The Columbia Architectural Design Review Team will meet on November 7, 2023 at **8:00 a.m.** in Conference Room A on the basement level of City Hall, 700 N. Garden Street to consider the following:

- I. Roll Call
- II. Approval of Minutes
- III. Old Business
- IV. New Business
 1. Request from Rachel Bovee for facade renovation approval within a Special District at [2412 Precast Drive](#).
 2. Request from Allison Corolla for new construction facade approval of an indoor facility within a Planned Unit Development at [Tax Map 42 Parcels 13, 13.07 and 13.09, off Hospitality Drive](#).
 3. Request from Brookstone Group, LLC for facade modification approval within a Planned Unit Development at Tax Map 42 Parcel 13.08, being [2500-2524 Hospitality Drive](#).
 4. Request from Greg Gamble for new construction facade approval within a Planned Unit Development at [400 Bear Creek Pike](#).
 5. Request from Derek Ransom for facade modification to proposed structure within a Planned Unit Development at [322 E. James M. Campbell Blvd](#).
- V. Adjourn

City of Columbia
ARCHITECTURAL DESIGN REVIEW TEAM
October 10, 2023

1 plan north elevation
1/8" = 1'-0"
SCALE FEET

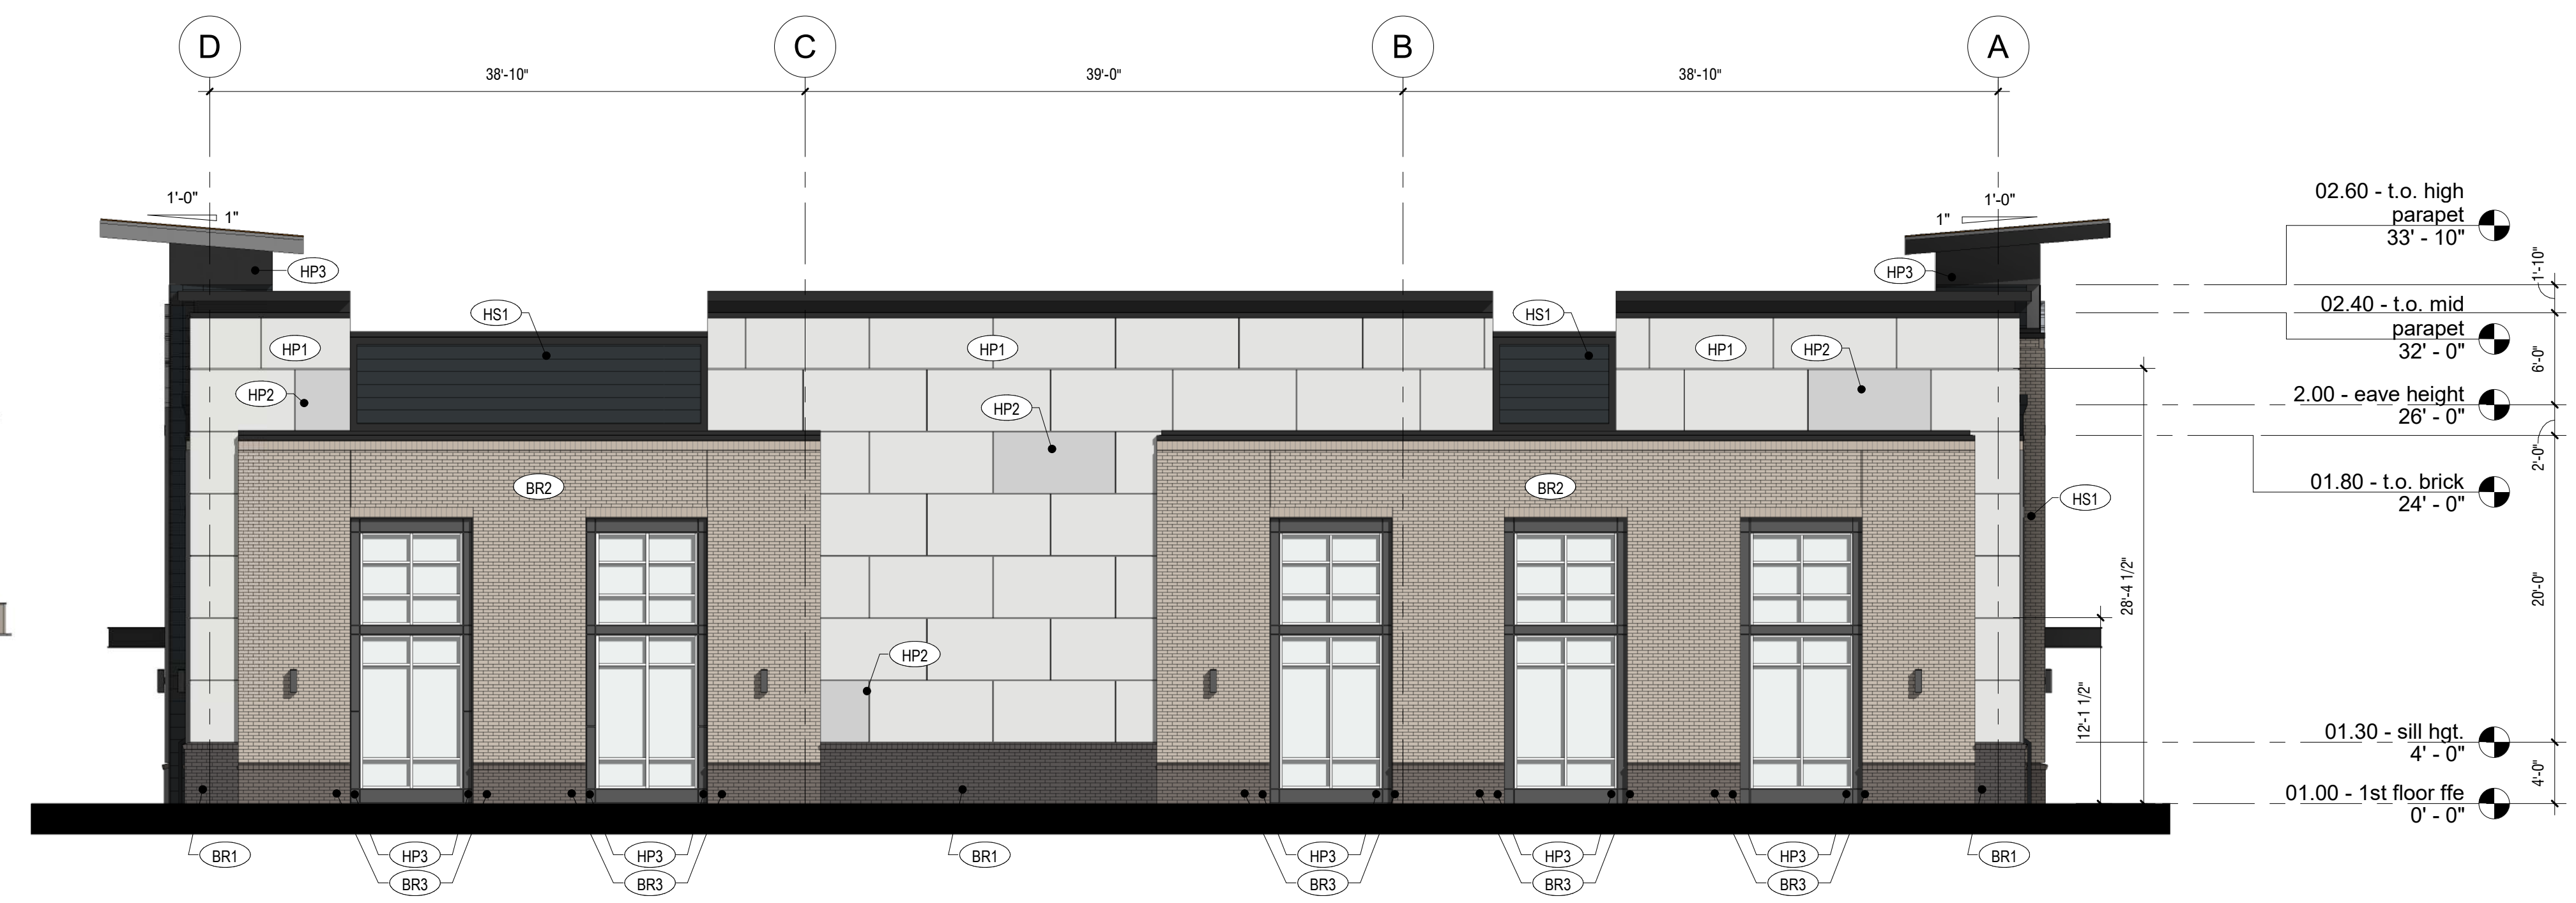
- This façade modifications included the replacement of non-conforming metal siding to be replaced with NICHIIHA siding (wood grain fiber cement board siding) on the upper parapet. All modifications have been installed per the approvals with the minor exception of a paint color change from white to dark gray with the removal of wall mounted light scones.

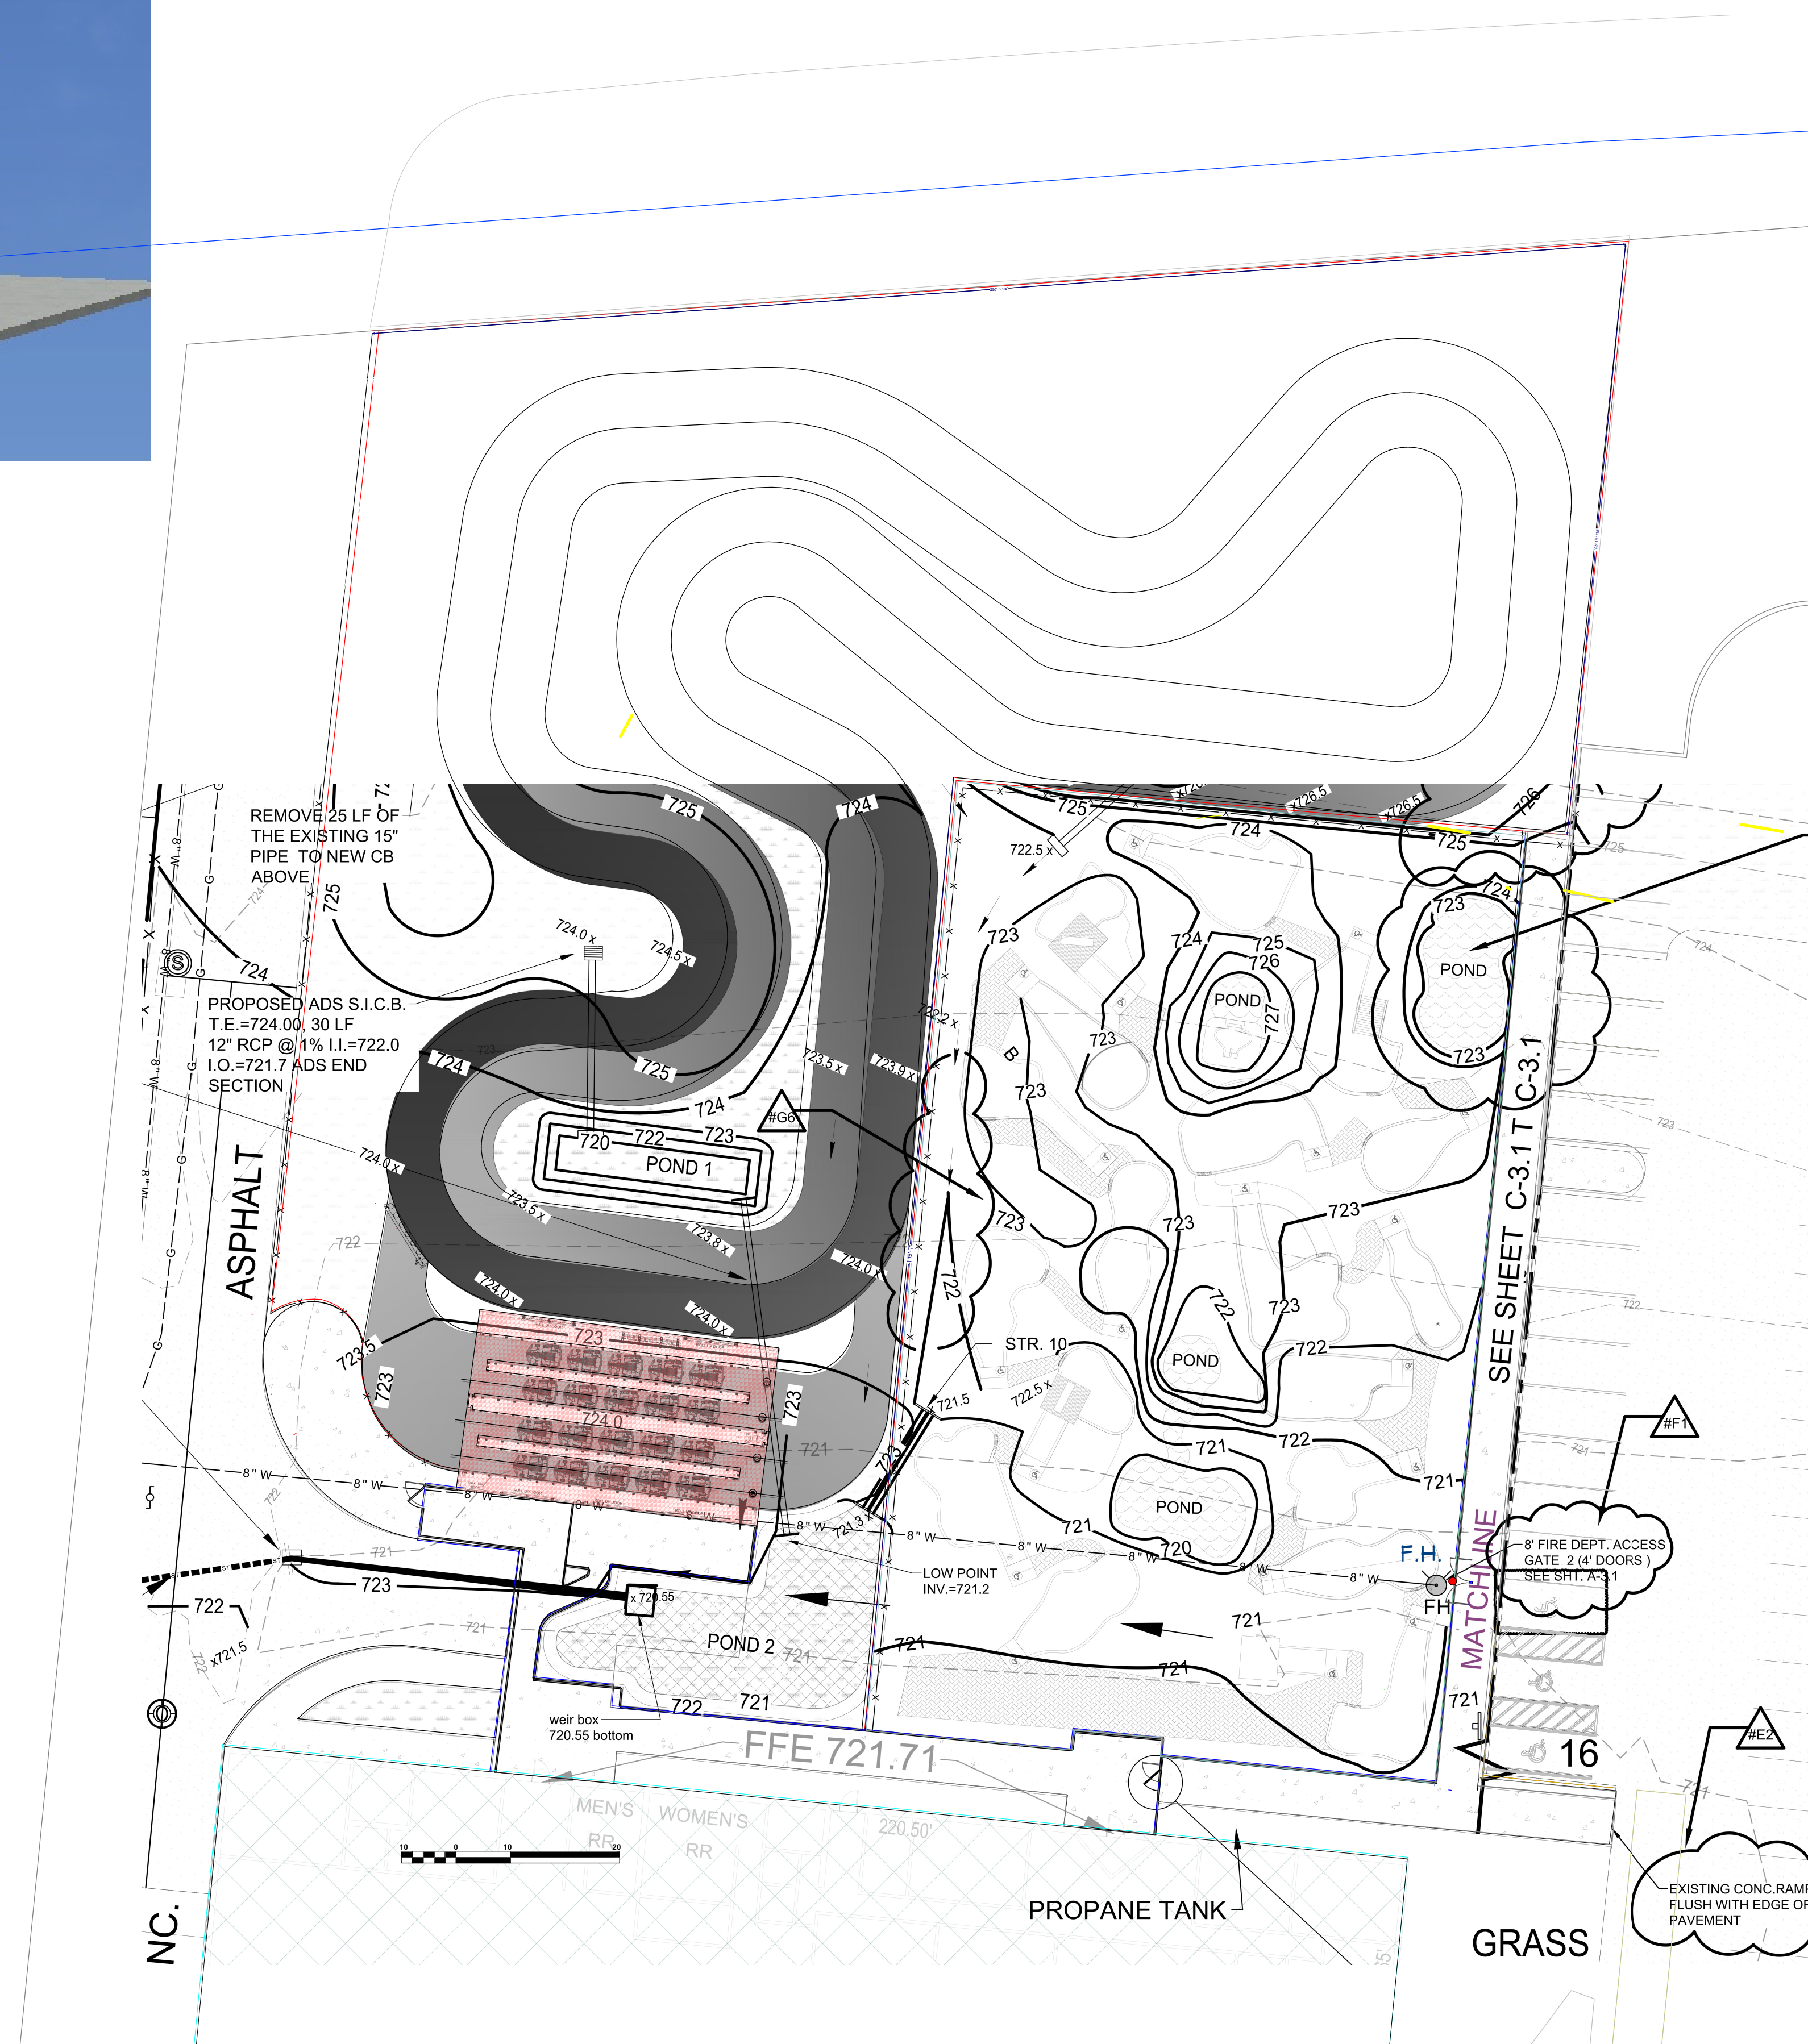
- This design review approved a design for the construction of a 15-foot-tall freestanding canopy structure to serve as go-kart the storage. The Design Review Team conditioned approval on the partial cladding of the columns with brick and a stone cap. This revision modifies the previous approval with only (4) of the columns containing a brick base. The previous approval was conditioned that all columns have a brick clad base on the exterior of the structure. This request utilized steel columns in lieu of wood columns in the previous request.
